Interactive comment on “Flexural behaviour of selected plants under static load” by F. J. Sutili et al.

Final response to referee 3 - General comments The MS deals with a relevant issue in soil bioengineering techniques application: the biotechnical properties of vegetation for riverbank stabilisation. The idea to introduce the angle of flexibility in order to evaluate such properties is valuable. The structure of the MS, the elaboration of results and the discussion, however, must be improved. The Authors are invited to rethink the MS and to make major revision

Fig. 3: Relationship between diameter (d) and load (F). Solid line: F_{elast} at the proportional limit; dashed line: F_u at the point of rupture.

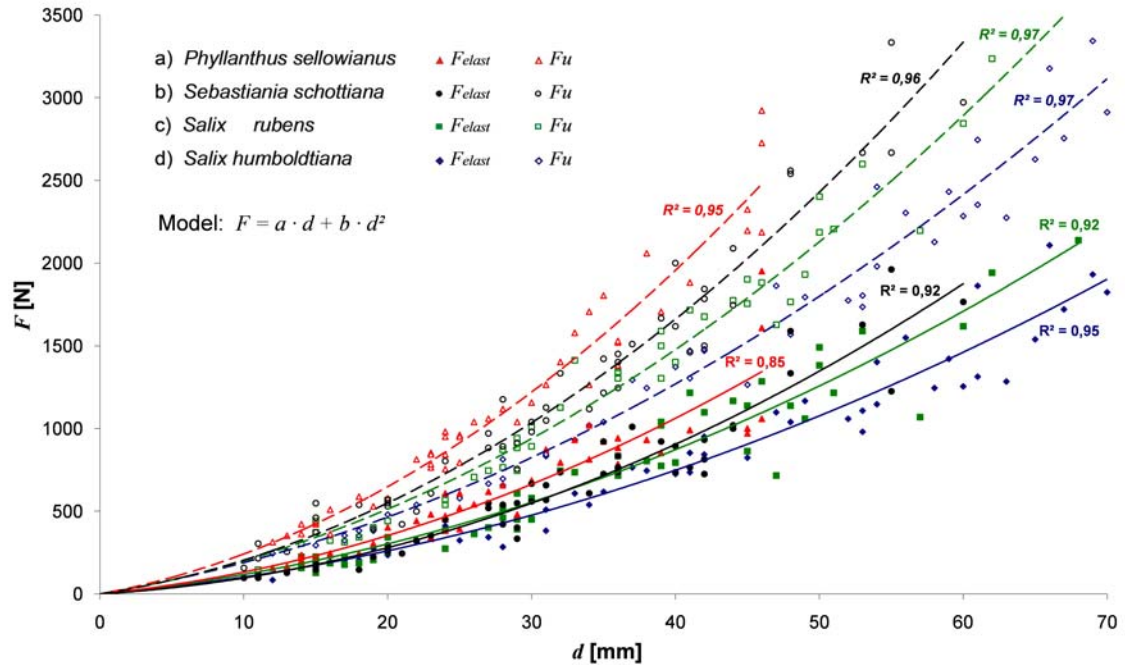
- In Figure 4 the entire lines should be drawn.

RESPONSE: This graph was revised (see fig. 1):
